**TORNILLO-GUADALUPE PORT OF ENTRY
PROJECT ZONE SEWER FACILITY
Bid # 12-0222
ADDENDUM NO. 1**

PROJECT NAME
TORNILLO-GUADALUPE
PORT OF ENTRY PROJECT
ZONE SEWER FACILITY

SHEET TITLE
6-INCH FORCE MAIN
PLAN & PROFILE
FROM STA. 43+00
TO STA. 63+00
C2.6R
SHEET 29R OF 50

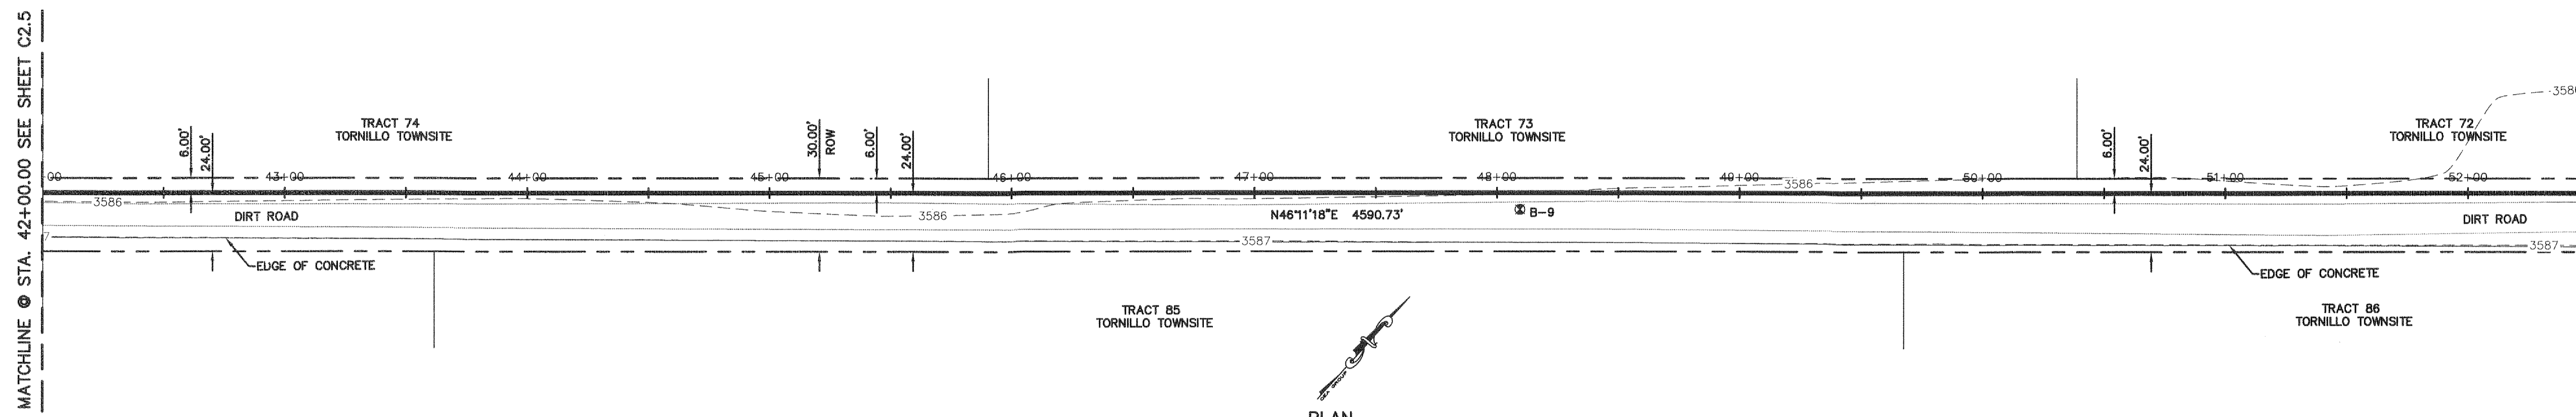
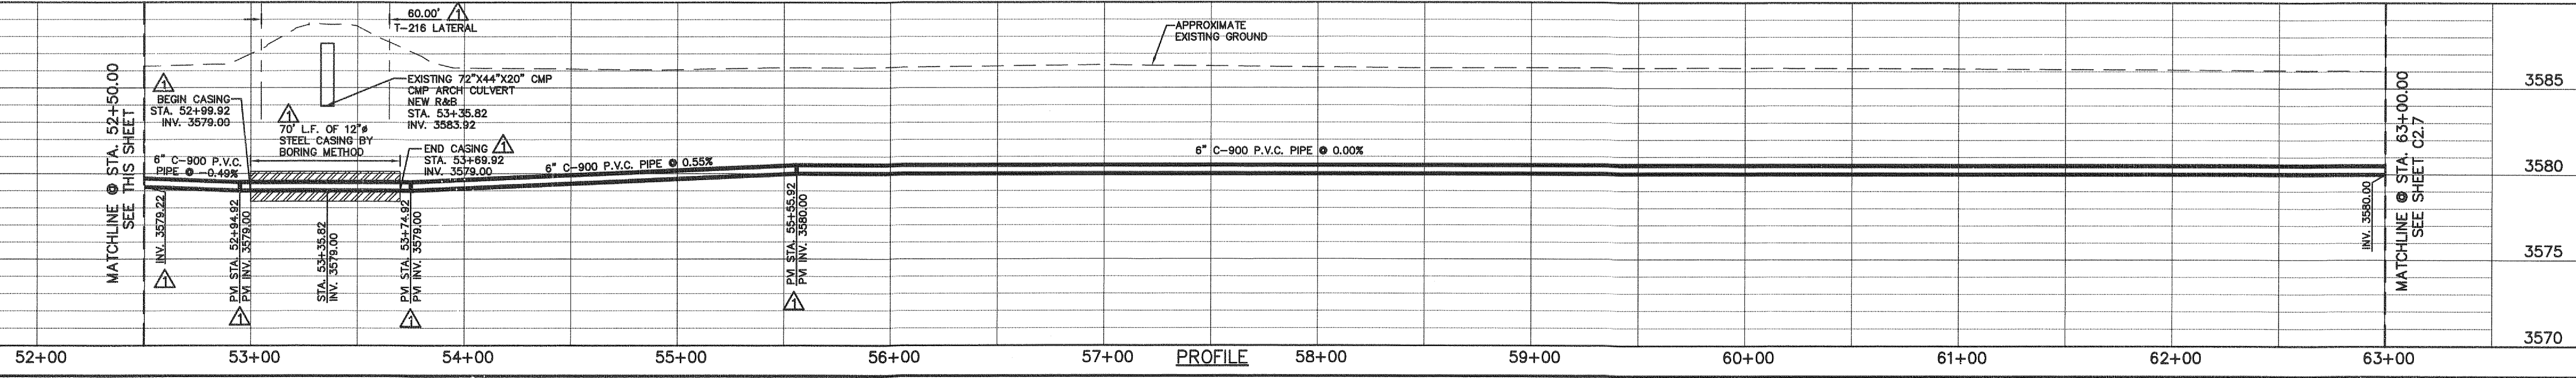
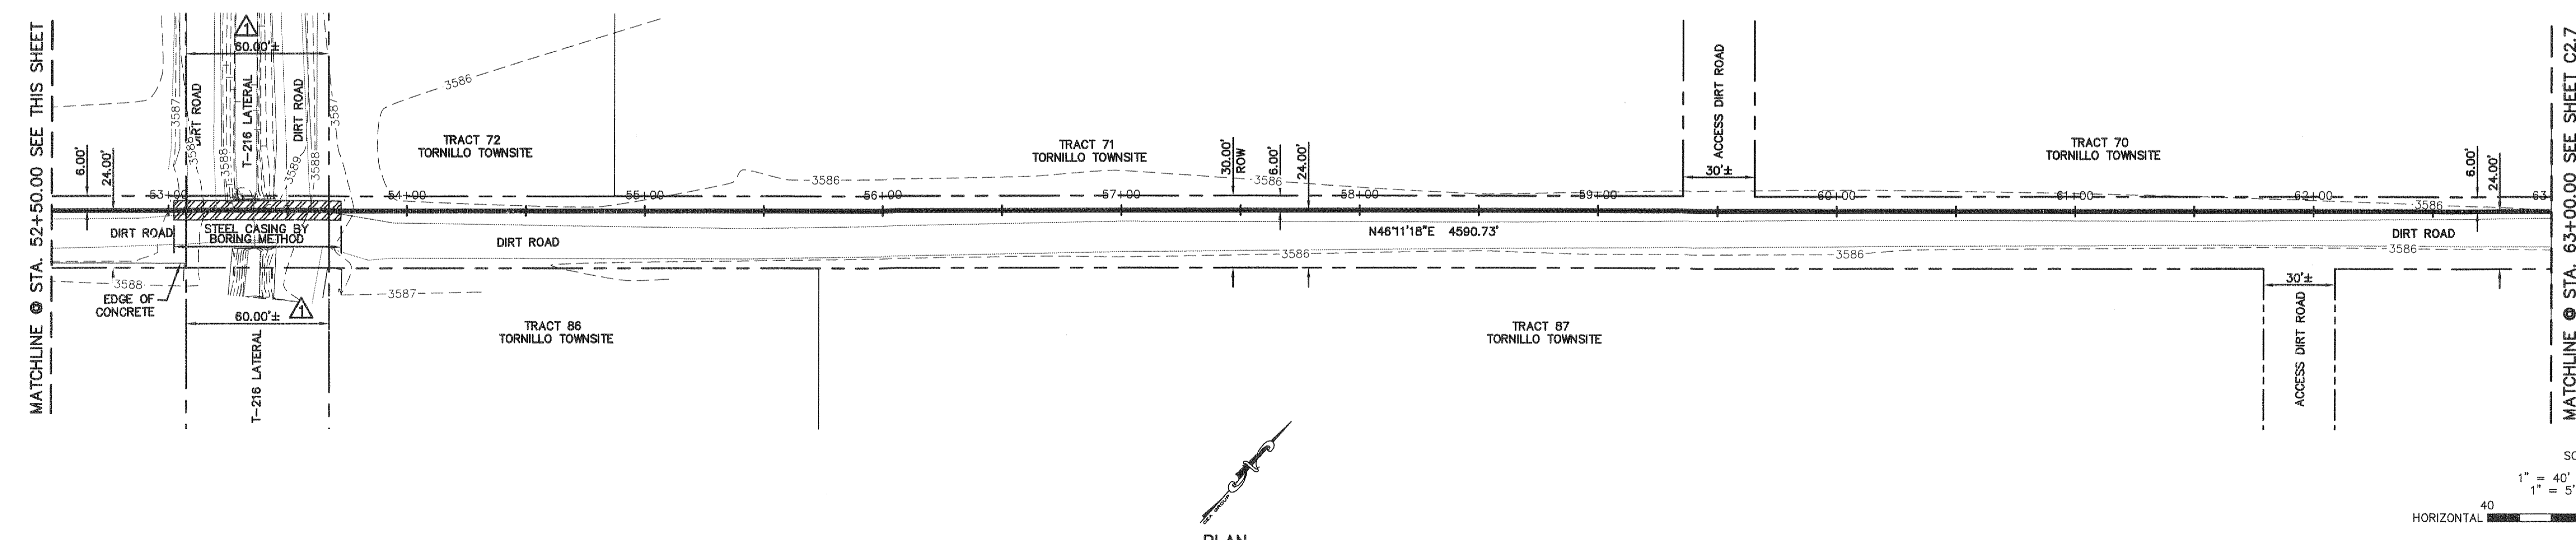
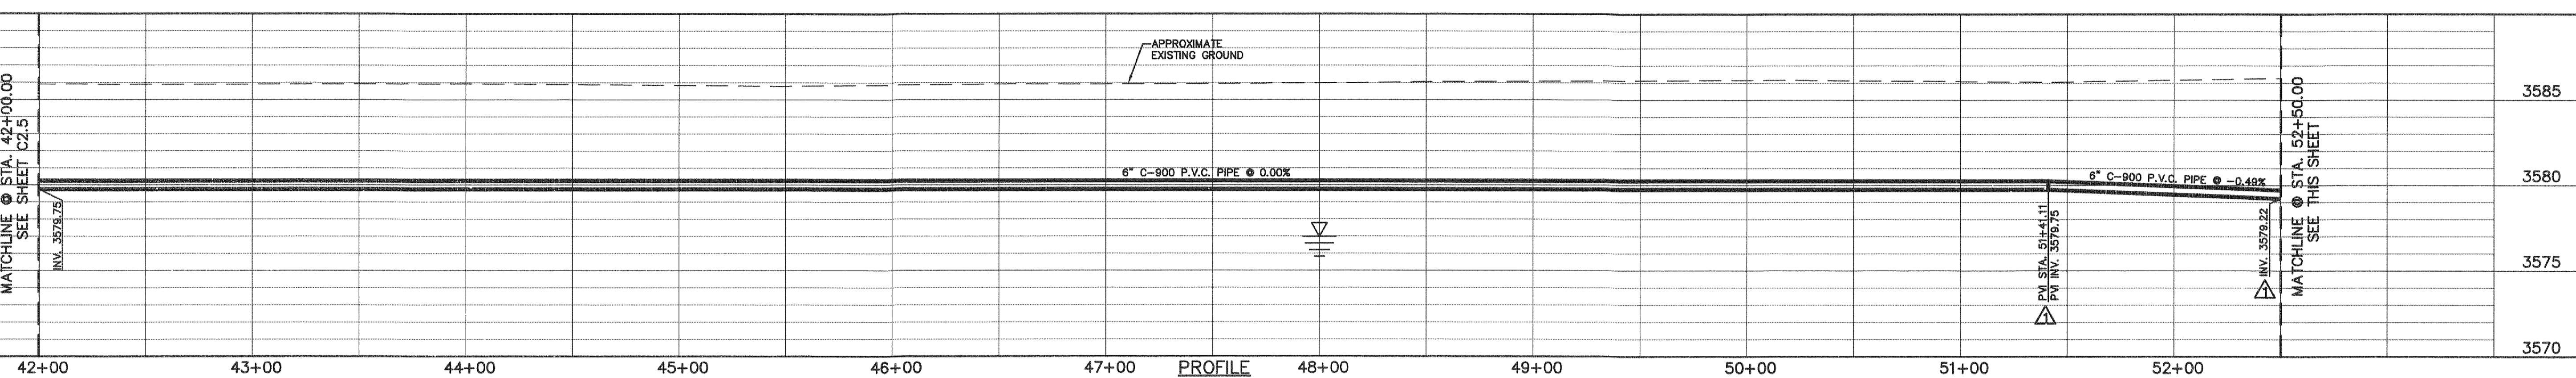
1.09	C2.6 Sheet 29 of 50	6-INCH FORCE MAIN PLAN & PROFILE FROM STA. 43+00 TO STA. 63+00. REMOVE Sheet C2.6 in its entirety and REPLACE with the Attached Sheet C2.6R in “Attachment E”.

NO. DATE	REVISION	REMARKS
1	5/13/12	ADDENDUM NO. 1 (1-216 ROW & STATIONING ADJUSTED)

**TEMPORARY EARTHEN IRRIGATION DITCH PLAN
DURING CONSTRUCTION**

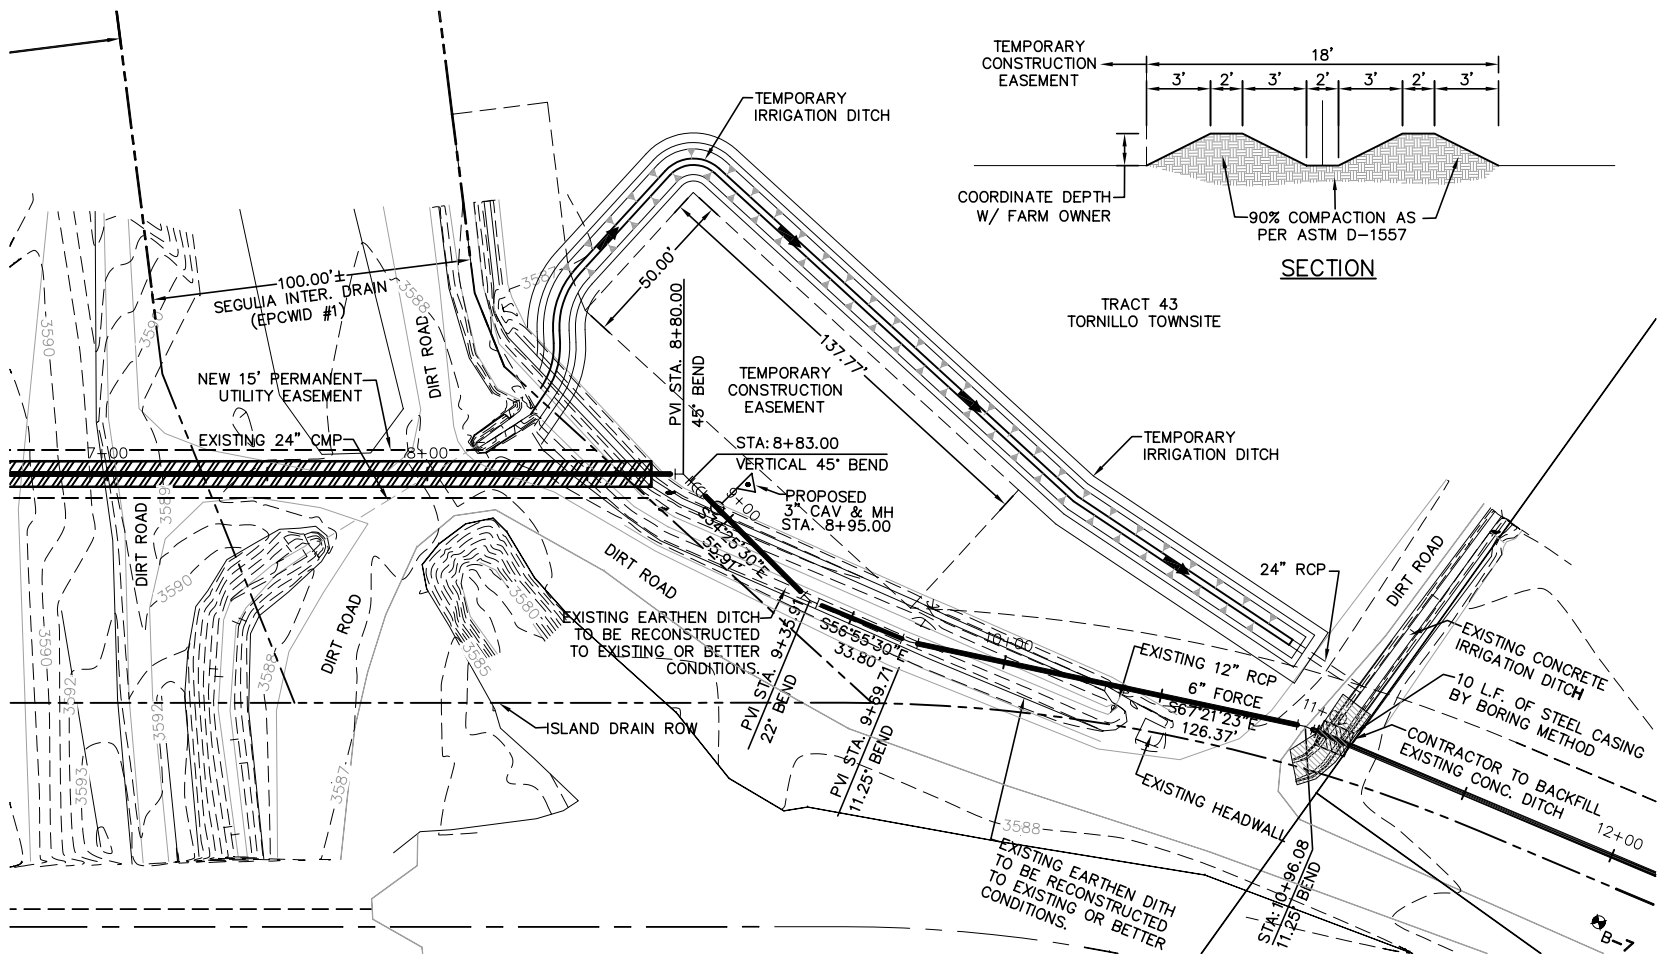
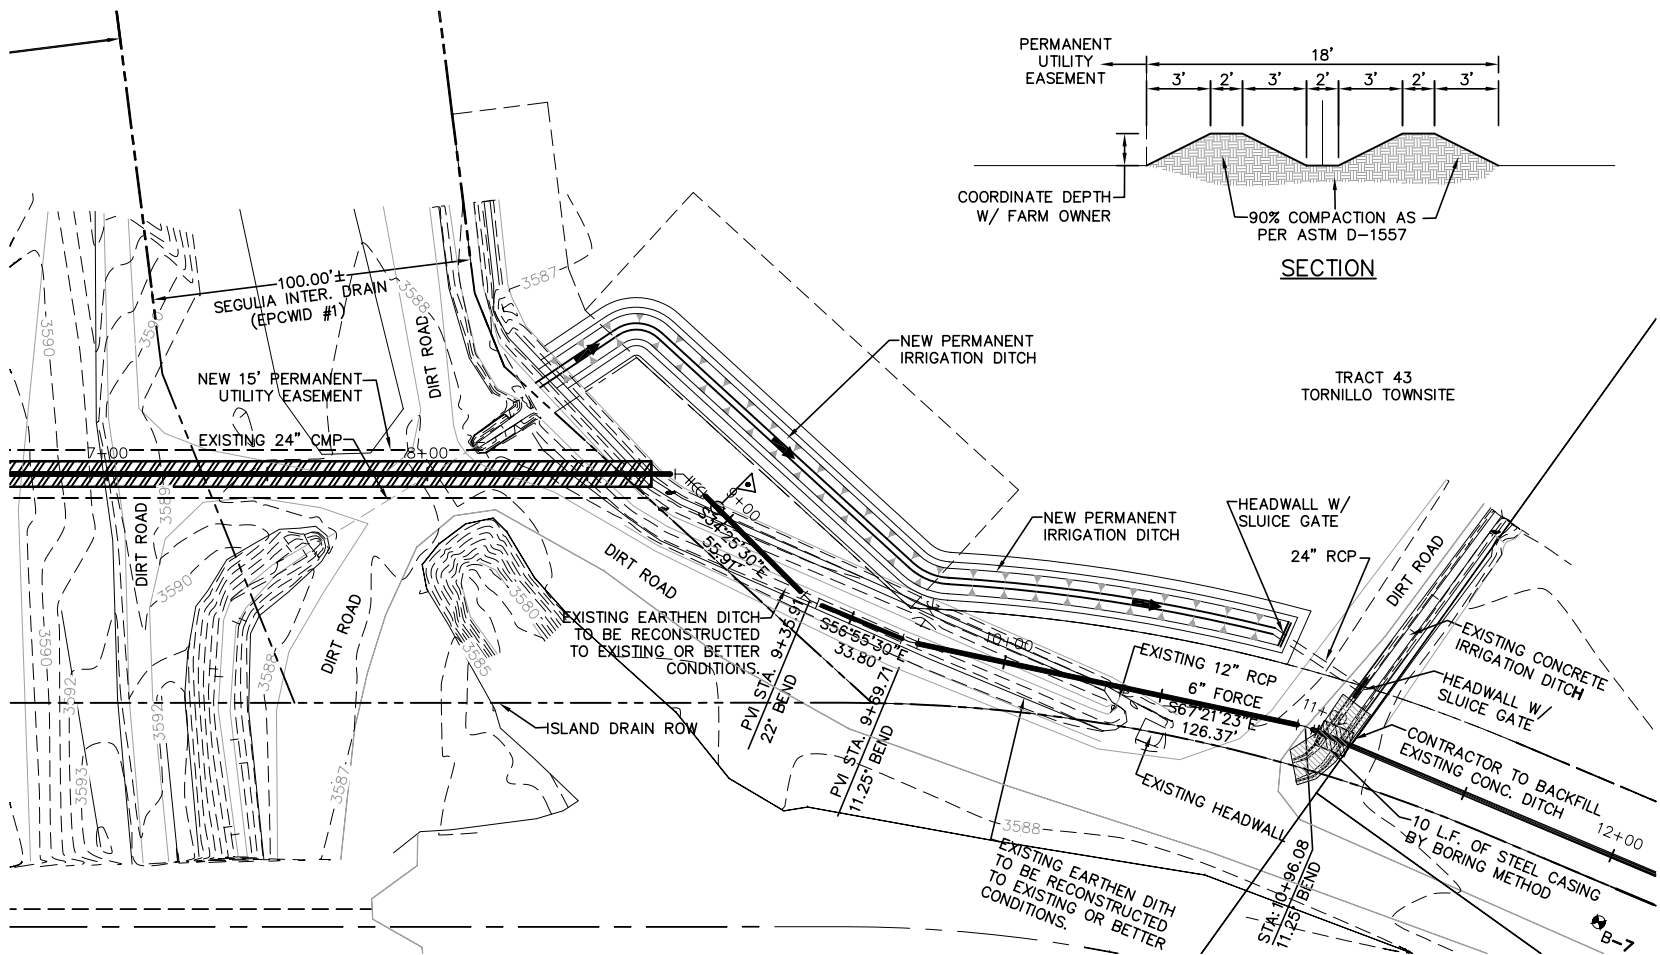
1.10	C2.6R Sheet 29 of 50	ADD TEMPORARY EARTHEN IRRIGATION DITCH PLAN DURING CONSTRUCTION, detail as shown in “Attachment F.”
1.11	C2.6R Sheet 29 of 50	ADD NEW EARTHEN IRRIGATION DITCH PLAN AFTER CONSTRUCTION, exhibit as shown in “Attachment G.”

1. EXISTING IRRIGATION PIPES WITH GATES TO BE RELOCATED AND INSTALLED IN COORDINATION WITH FARMER.

1R
C4.6 COMBINATION AIR RELEASE VALVE INSTALLATION DETAILS
SCALE: N.T.S.

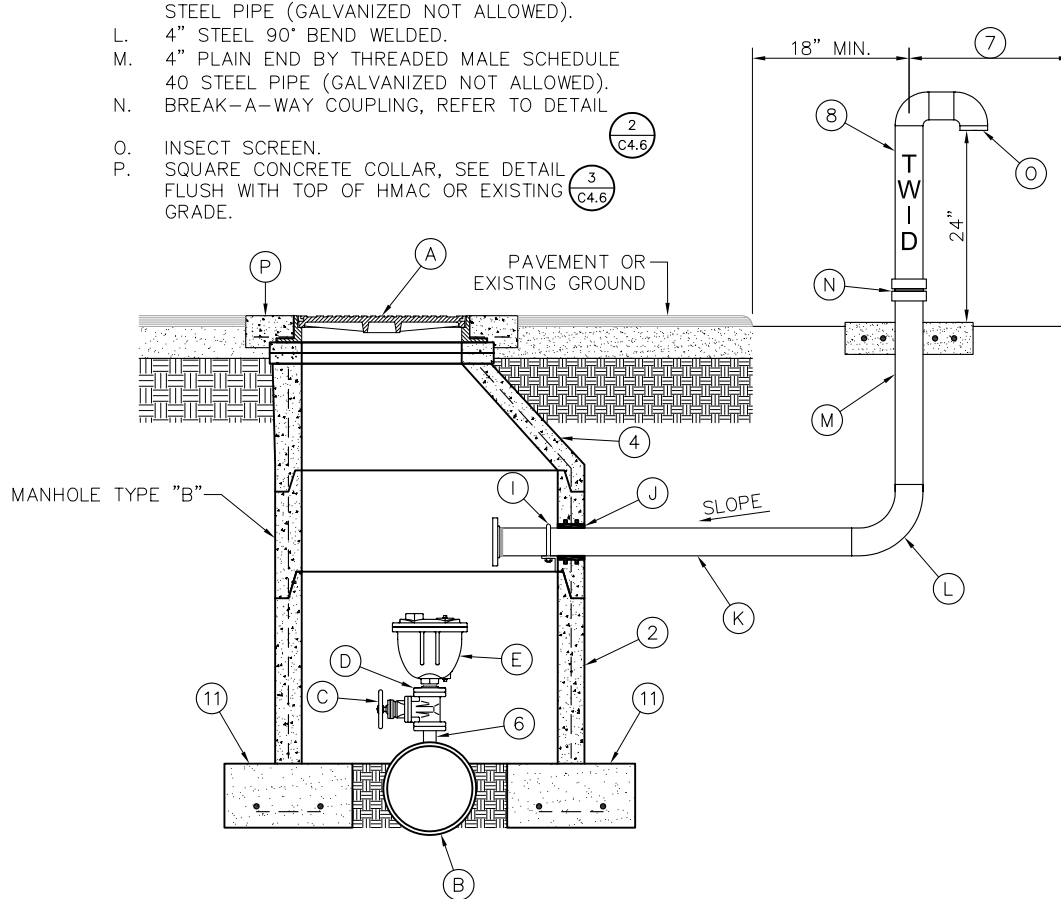
1.16	C4.6 Sheet 46 of 50	SANITARY SEWER PIPE CONNECTION DETAILS. REMOVE Detail 1/C4.6 “Combination Air Release Valve Installation Detail,” in its entirety and REPLACE with the Attached Detail 1R/C4.6 “Combination Air Release Valve Installation Detail,” in “Attachment I”.

- A. REFER TO DETAILS 3
C4.5 6
C4.5.
- B. MAINLINE, SIZE AS SPECIFIED.
- C. 3" FLANGED GATE VALVE (ISOLATION VALVE).
- D. 3" CAST IRON COMPANION FLANGE.
- E. 3-INCH VENT-O-MAT AIR 080-RGX-1031 (NO SUBSTITUTES WILL BE ALLOWED)
- F. (NOT USED)
- G. (NOT USED)
- H. (NOT USED)
- I. ANCHOR PIPING TO VALVE VAULT WITH 3"x3"x1/4" ANGLE & 3/8"Ø STRAP.
- J. PIPE WALL SLEEVE (LINK SEAL OR EQUAL).
- K. 4" FLANGED BY PLAIN END SCHEDULE 40 STEEL PIPE (GALVANIZED NOT ALLOWED).
- L. 4" STEEL 90° BEND WELDED.
- M. 4" PLAIN END BY THREADED MALE SCHEDULE 40 STEEL PIPE (GALVANIZED NOT ALLOWED).
- N. BREAK-A-WAY COUPLING, REFER TO DETAIL 2
C4.6
- O. INSECT SCREEN.
- P. SQUARE CONCRETE COLLAR, SEE DETAIL 3
C4.6 FLUSH WITH TOP OF HMAC OR EXISTING GRADE.
